NOTICE OF DECISION

MAP/TAX LOT: 2S131AB08200; 2S131AB08100;
2S131AB08000; 2S131BA08200
CASE NO: LU 2020-008 SP
DATE OF NOTICE: September 15, 2020

CITY OF SHERWOOD
September 15, 2020
Staff Report and Notice of Decision

SENESTRARO FAMILY ORTHODONTICS
SITE PLAN REVIEW
LU 2020-008

PRELIMINARY FIRE ACCESS & WATER SUPPLY PLAN

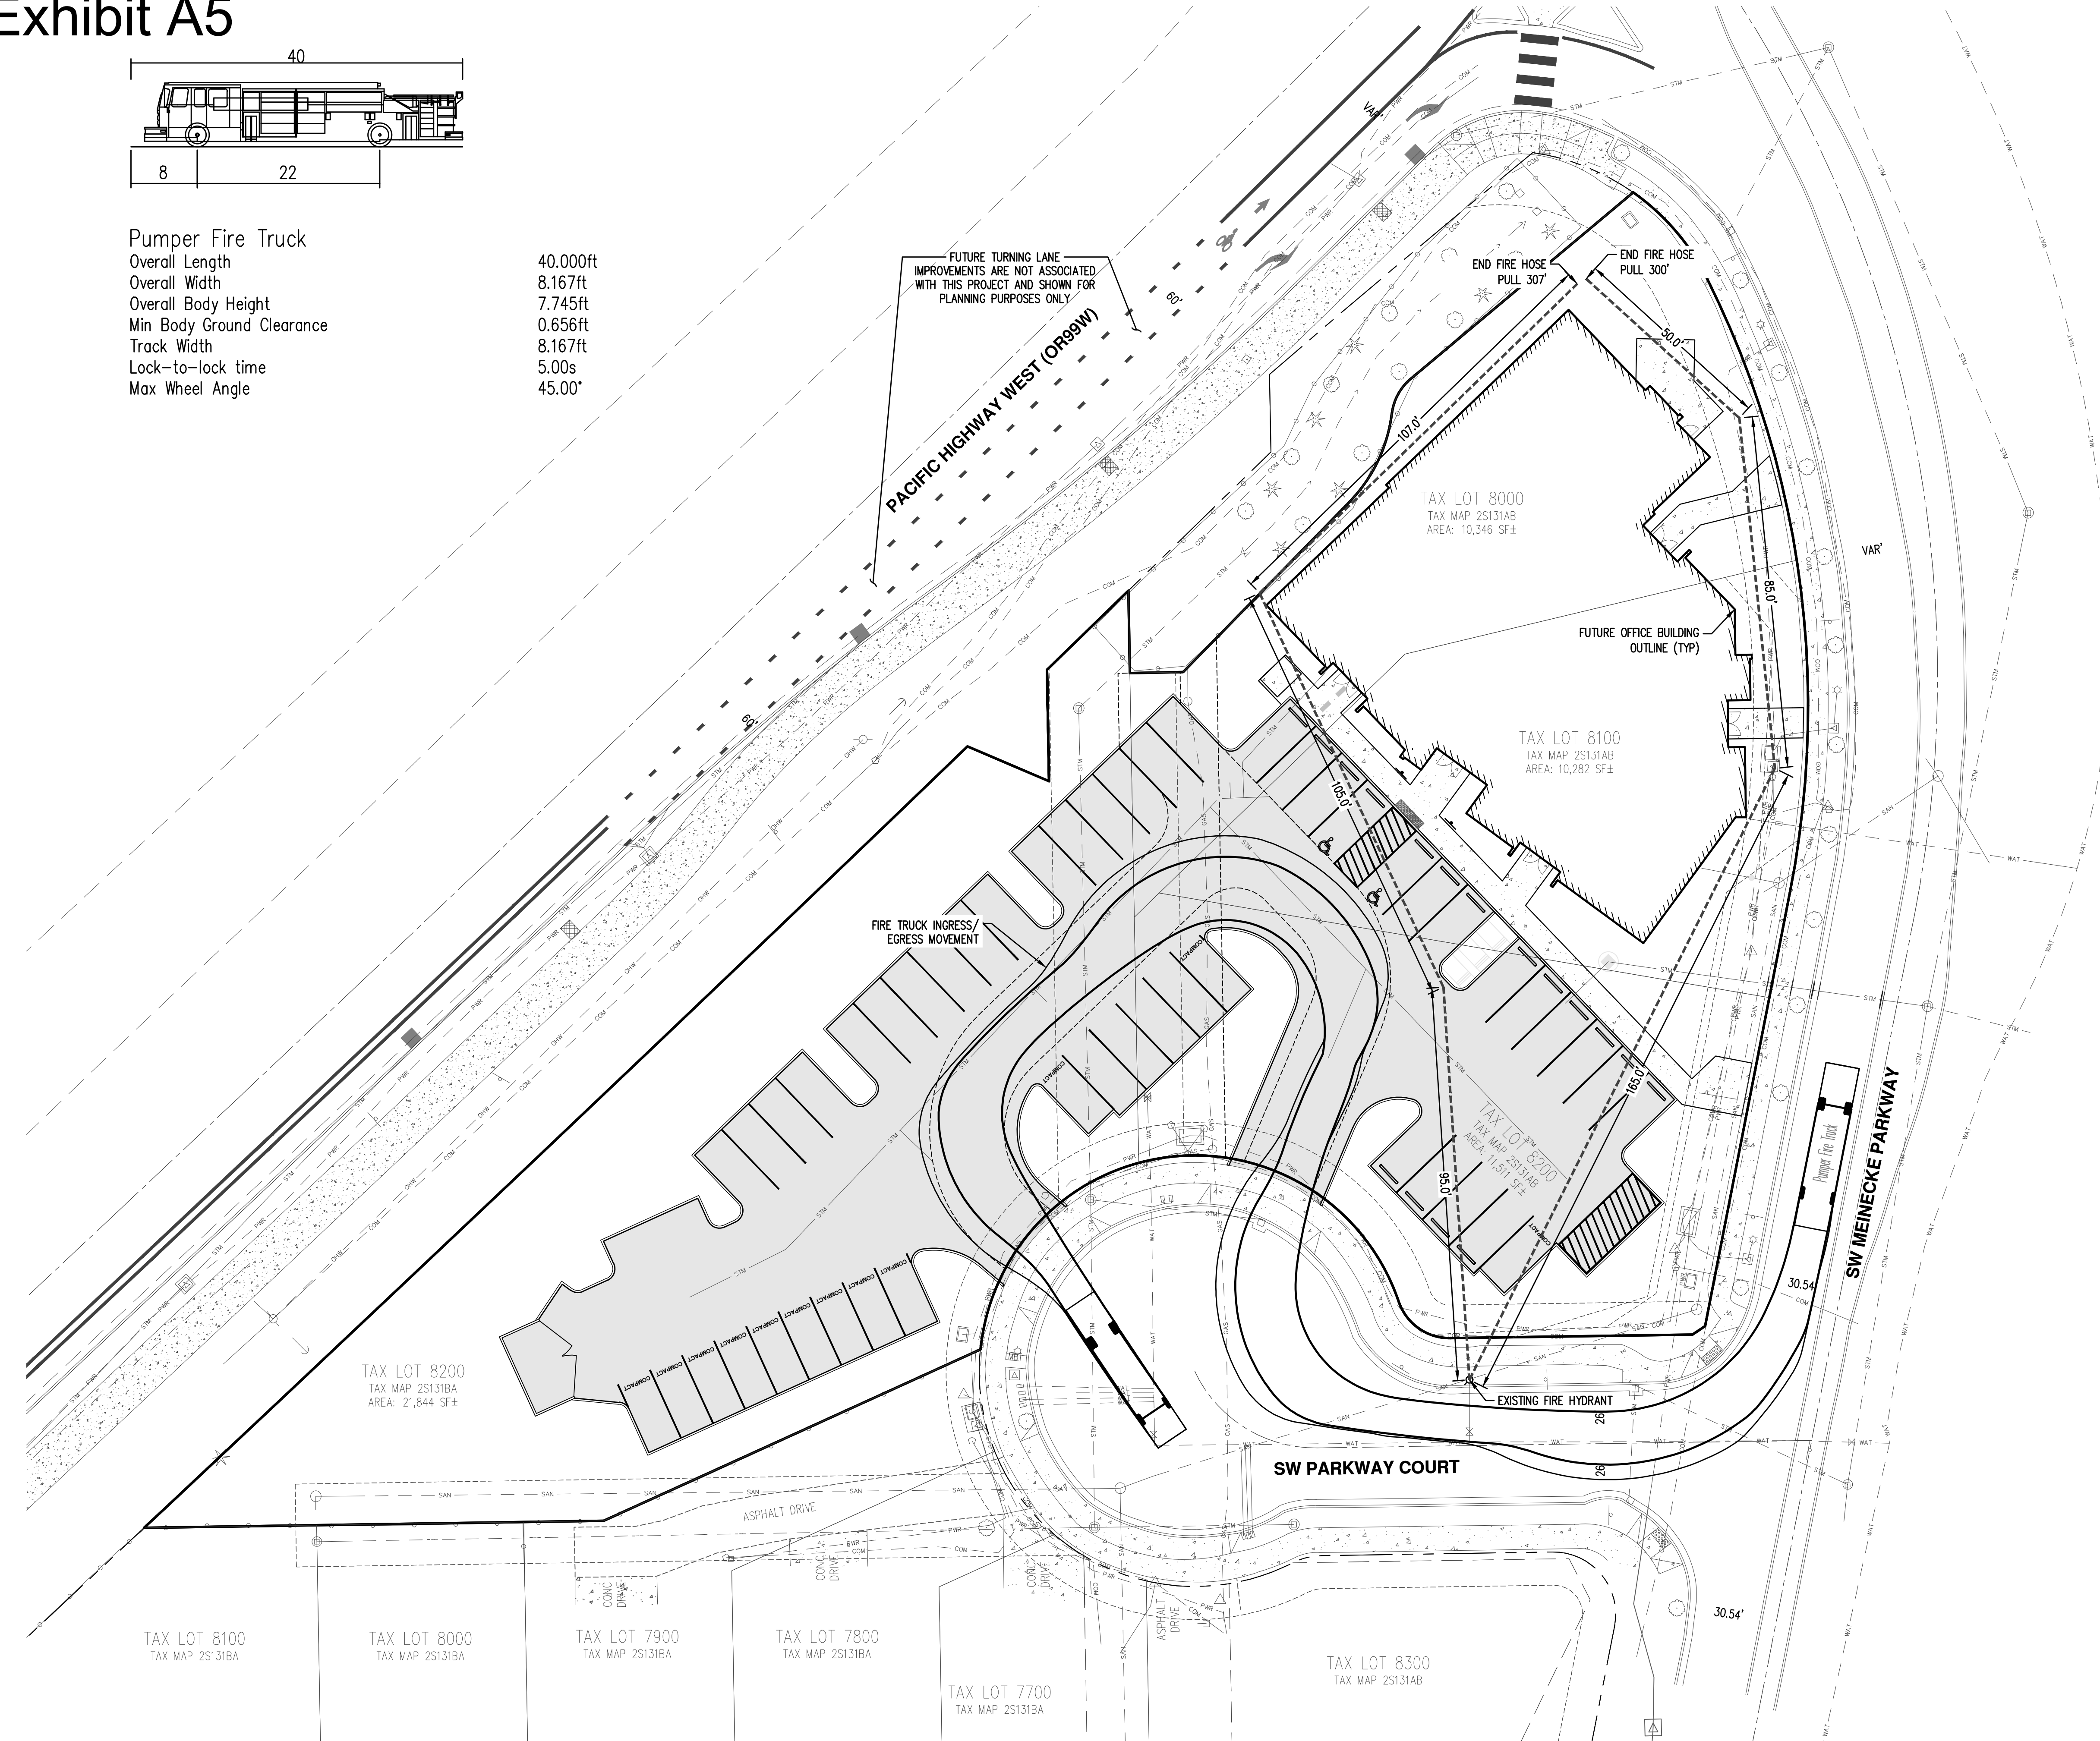
ANALYSIS: The applicant has submitted Preliminary Fire Access and Water Supply Plan (Exhibit A5 – Sheet P-06). Fire protection and emergency services are provided by Tualatin Valley Fire and Rescue (TVFR). Tom Mooney, Deputy Fire Marshall, provided a review letter dated August 28, 2020 (Exhibit B3) outlining fire protection requirements for the project. A condition of approval requiring compliance with the Fire Marshall’s letter is included below.

PRELIMINARY CIRCULATION AND DIMENSIONED SITE PLAN
SENESTRARO FAMILY ORTHODONTICS
SHERWOOD, OREGON

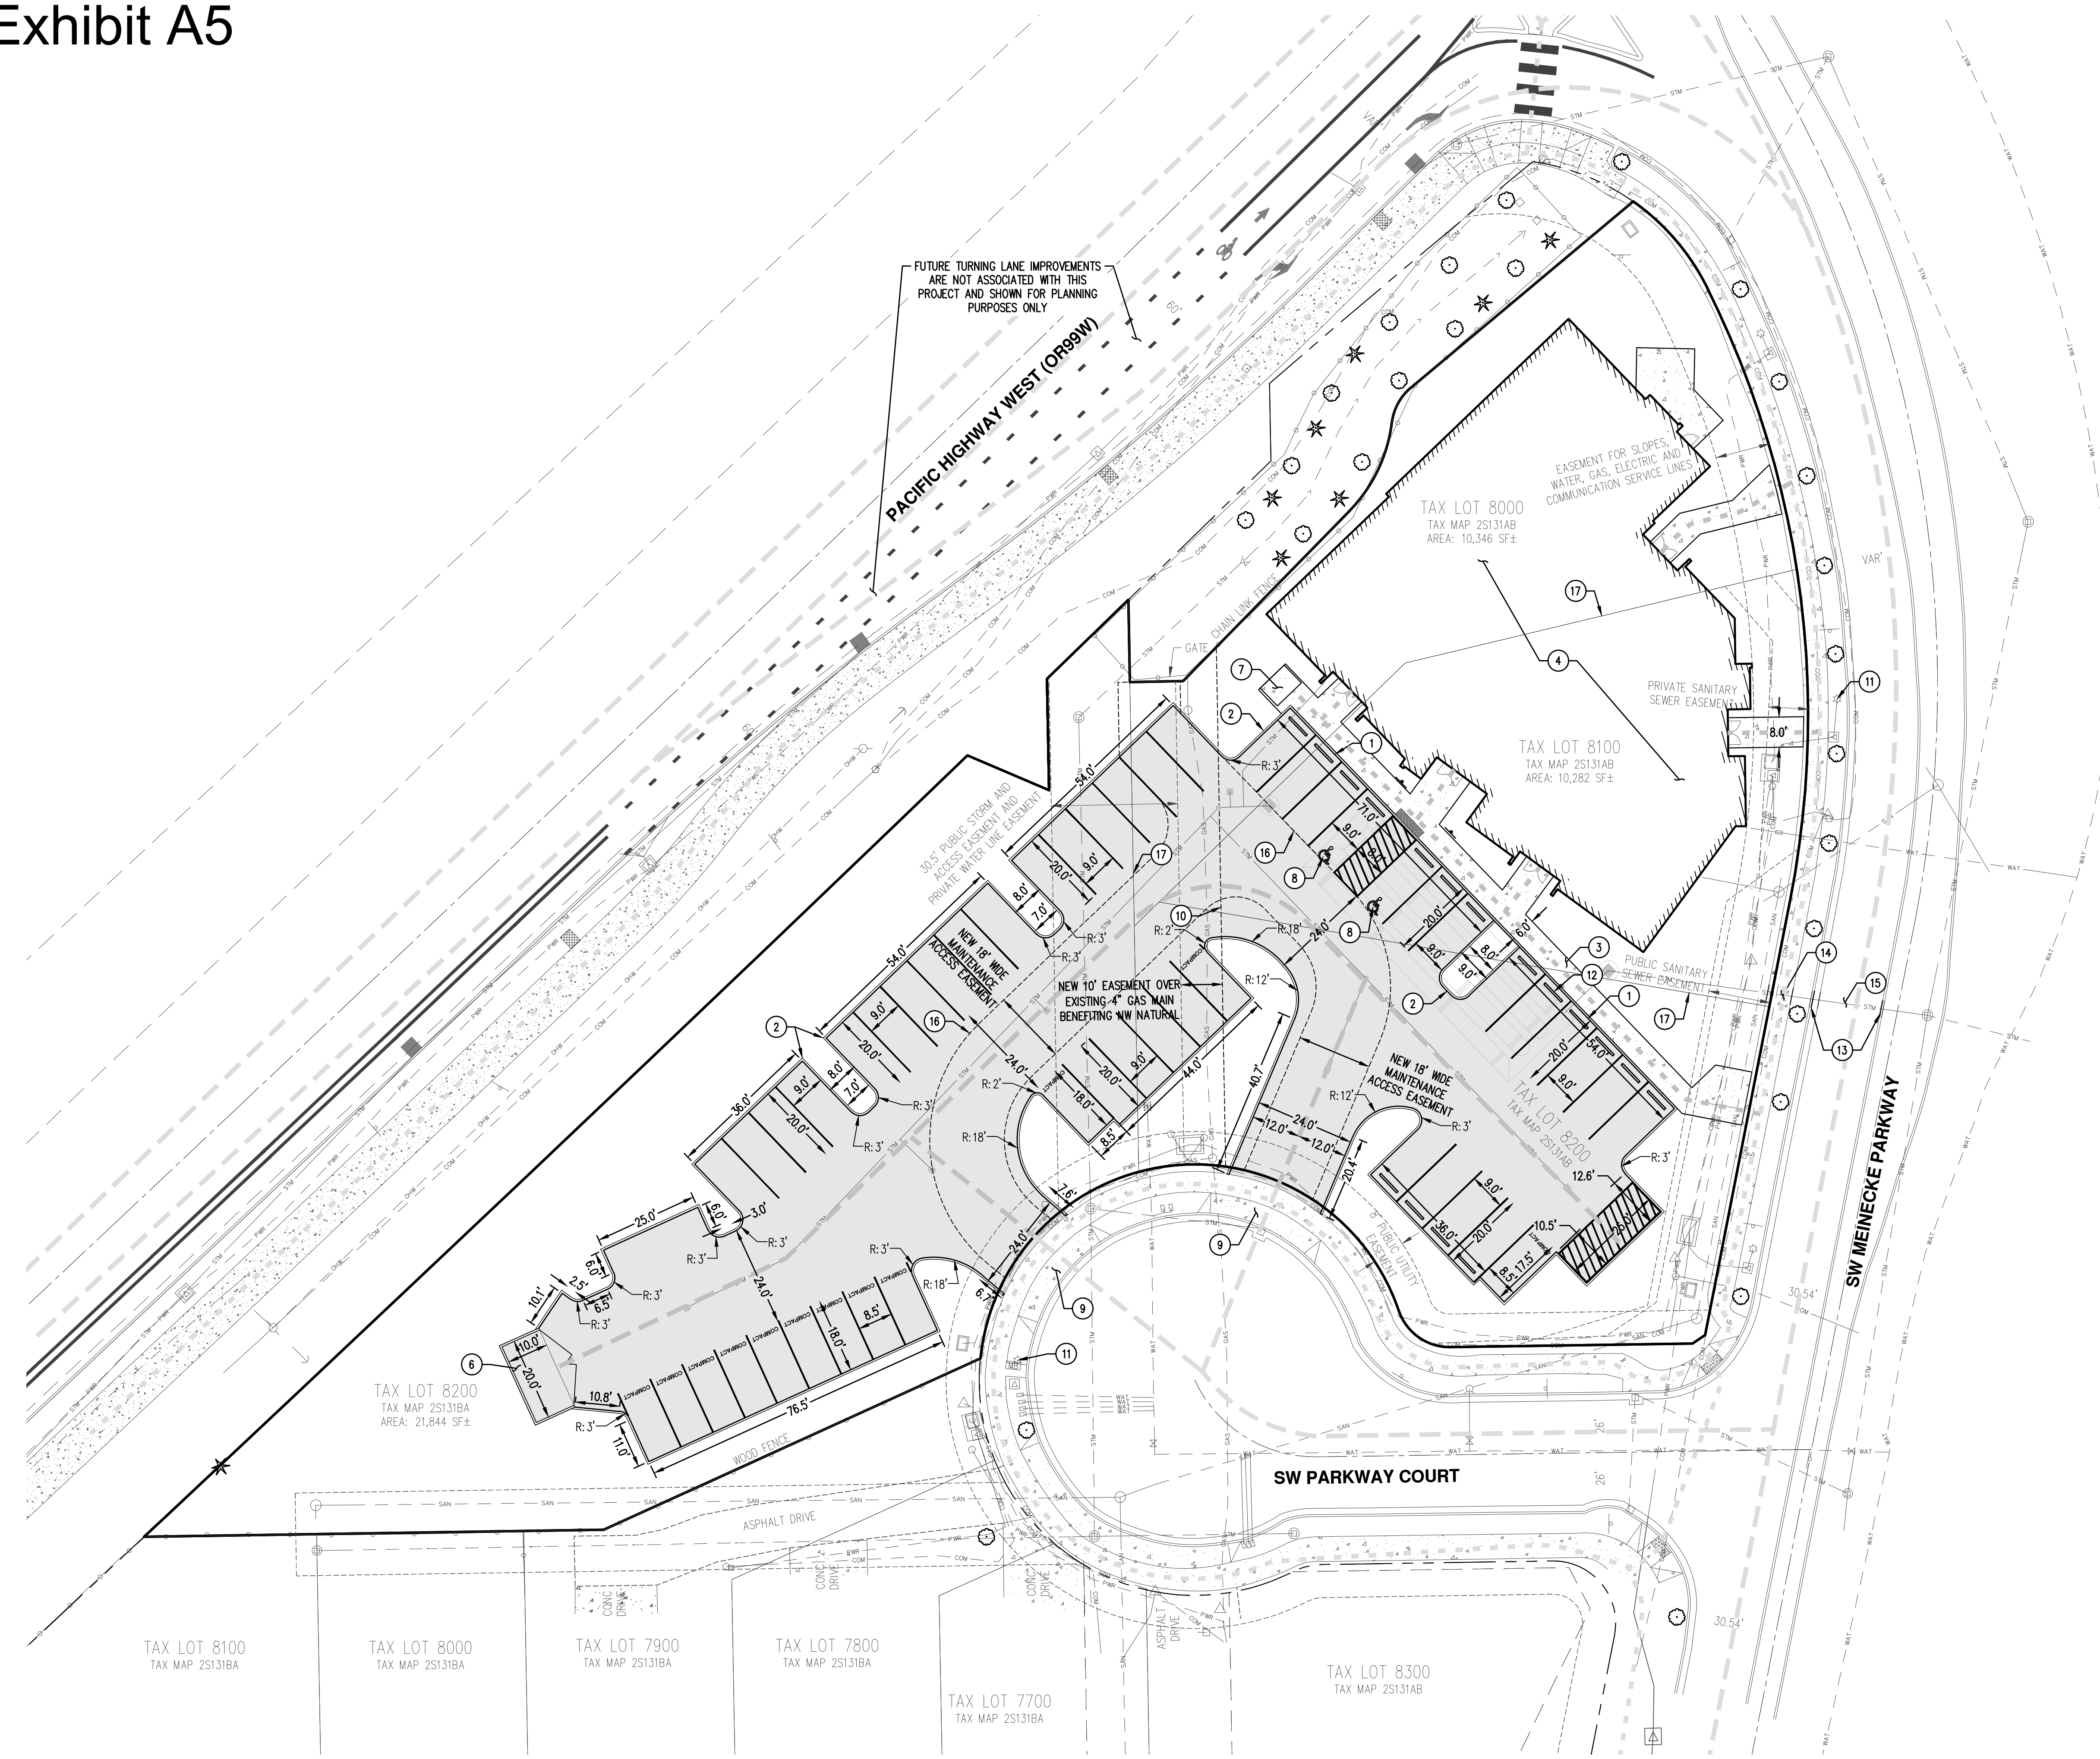
ANALYSIS: The Preliminary Circulation Plan (Exhibit A5 – Sheet P-07) provides details on the parking, loading, and maneuvering area marking. The plans show the existing and future vehicular and pedestrian circulation patterns for the site. The vehicle and loading stalls have been clearly delineated, including two ADA stalls. No circulation painting or signage is shown.

ANALYSIS: The Dimensioned Site Plan (Exhibit A5 – Sheet P-07) provides details on the parking area design and dimensions. The parking stalls are proposed at 90 degrees to the internal drive aisles. A 24 ft. wide two-way drive aisle will provide vehicle circulation throughout the parking area.

ANALYSIS: The Preliminary Circulation Plan (Exhibit A5 – Sheet P-07) shows the proposed vehicle and pedestrian circulation for the development site. Three (3) pedestrian pathways will be provided between the existing sidewalks along SW Meinecke Parkway and the building.
